**REMEDY NOTICE**  
 This is an important Safety Recall.  
 The remedy will be performed  
**FOR FREE.**

NHTSA Recall 18V-041

**IMPORTANT SAFETY RECALL**

Campaign #U0H / Service Bulletin #18-003

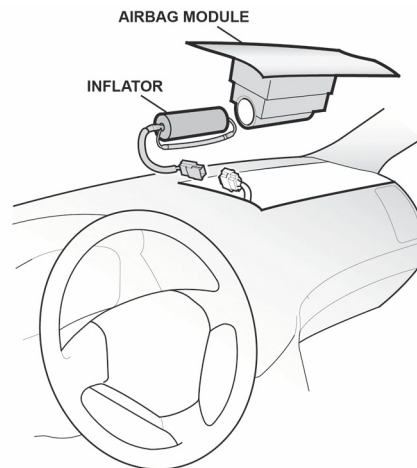
Acura has decided that a defect which relates to motor vehicle safety exists in certain 2009-2012 model year RL vehicles. The passenger frontal airbag inflator in your vehicle may explode when deploying during a crash. The potential for such explosion may occur in some of the subject airbag inflators after prolonged exposure to persistent conditions of high absolute humidity. In the event of a passenger frontal airbag inflator explosion, metal fragments could pass through the airbag cushion material, potentially resulting in injury to vehicle occupants. The risk of such an occurrence increases over time. It is imperative you schedule an appointment with an authorized Acura dealer now to avoid this condition in the future.

Acura will replace the passenger frontal airbag inflator for free. An illustration showing the location of the passenger frontal airbag inflator, which is the only component of the airbag module (other components are the airbag cushion and airbag module cover) that will be replaced, during the recall repair, is shown on the right:
